Notes regarding Uma's latest round of comments:

**STELLEN CONSULTING**  
Civil Engineering

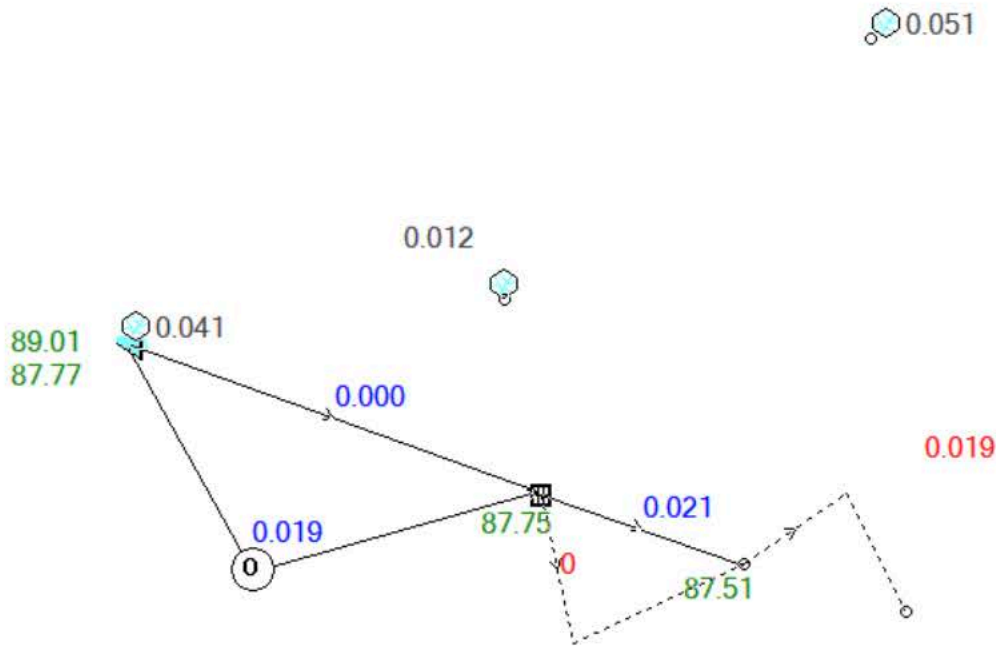
- Pipe layout has been modified to shift the orifice plate into the OSD (DR-001), discharge control pit has been removed (DR-001/DR-005) and the catchment plan has been updated (DR-006)
- Overflow is located above the top water level in the OSD (DR-005)
- OSD flows and Bypass flows have been separated in the drains model as requested. These have also been split in the table on DR-006 and shown separately and then totalled for comparison with the agreed PSD of 23l/s.
- Overflow pipe from the OSD tank has been included in the model as an additional orifice in the tank at IL 88.85 and was checked by reducing the orifice outlet to 1mm to simulate a blockage. The overflow is capable of conveying the 1% AEP event in this scenario as demonstrated in the screen shot below:
